Engineer: P McGill			
Title: Coastal Profiling Float Motherboard: Power Supplies			
Size: C	Document Number: 11021161		Rev: 1.8.0
Date: Thursday, December 22, 2016	Sheet 2 of 3

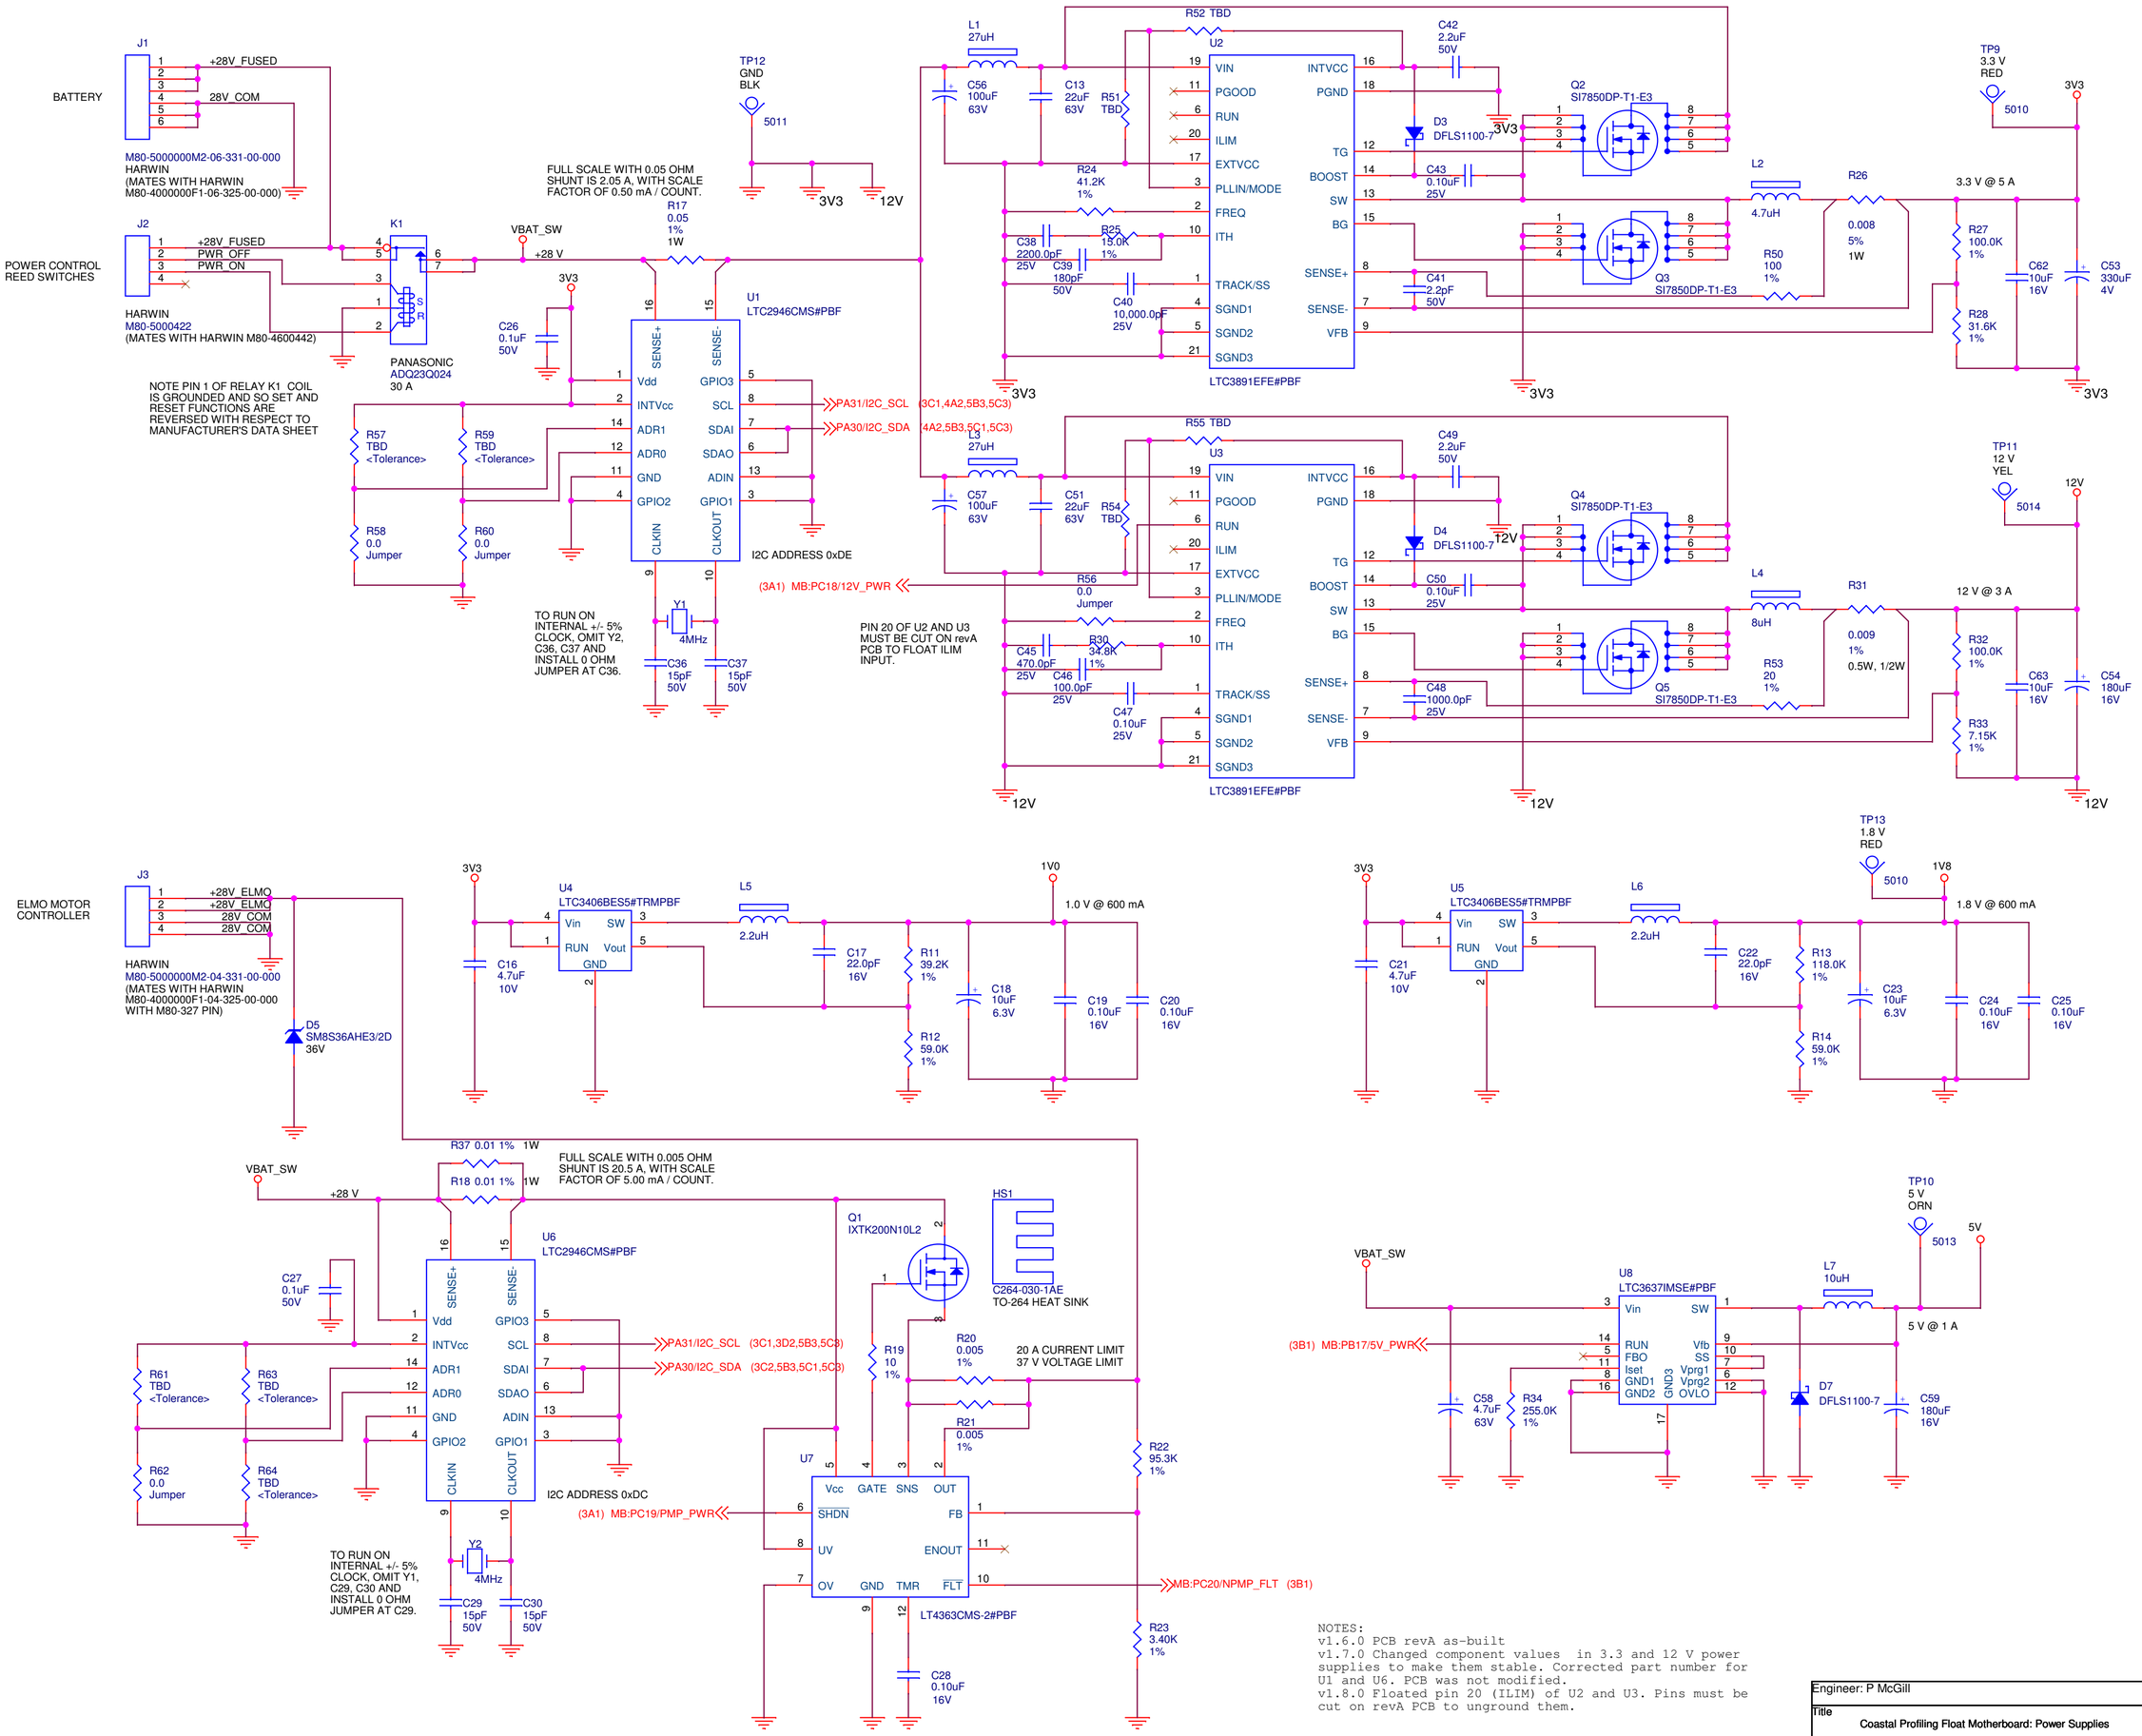
NOTES:
v1.6.0 PCB revA as-built
v1.7.0 Changed component values in 3.3 and 12 V power supplies to make them stable. Corrected part number for U1 and U6. PCB was not modified.
v1.8.0 Floated pin 20 (ILIM) of U2 and U3. Pins must be cut on revA PCB to unground them.
